Transtech **Bulletin**

APPLICATION: Chrysler A604
SUBJECT: Solenoid Body Gasket 1989-Up

NEW
TRANSTEC #12544
CHRYSLER #4659982

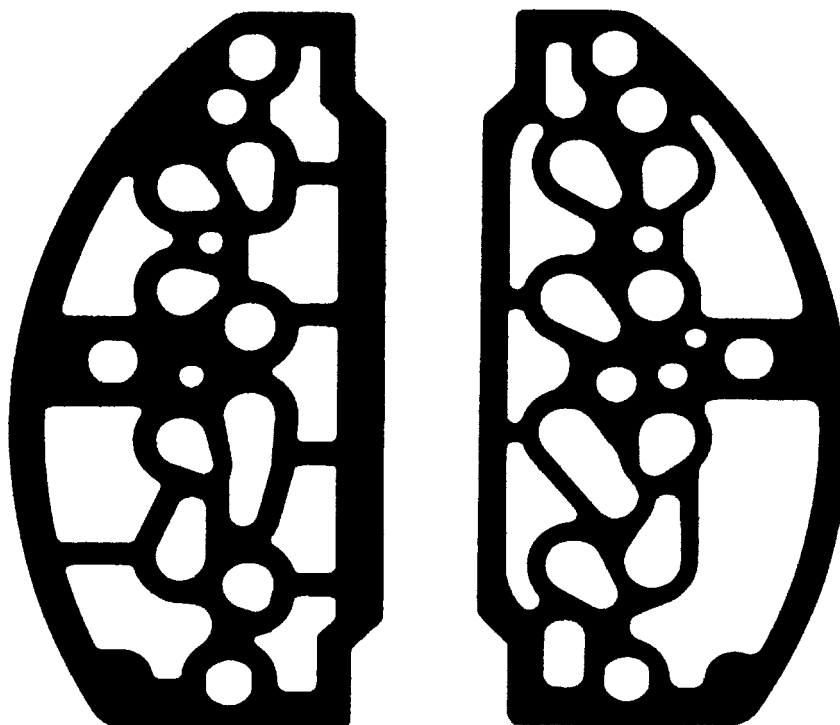
The Chrysler A604 solenoid body and gasket have been substantially revised. Brought out for production and service in 2000, the new assembly requires only one gasket between the case and solenoid. The new assembly will eventually supersede all previous solenoid bodies in production and service.

THE SEPARATOR PLATE MUST BE DELETED WHEN USING THE NEW DESIGN SOLENOID AND GASKET ON 89-UP MODELS.

Solenoid assembly #5015646AB will retrofit to all models 1989-up when used with the latest design gasket.
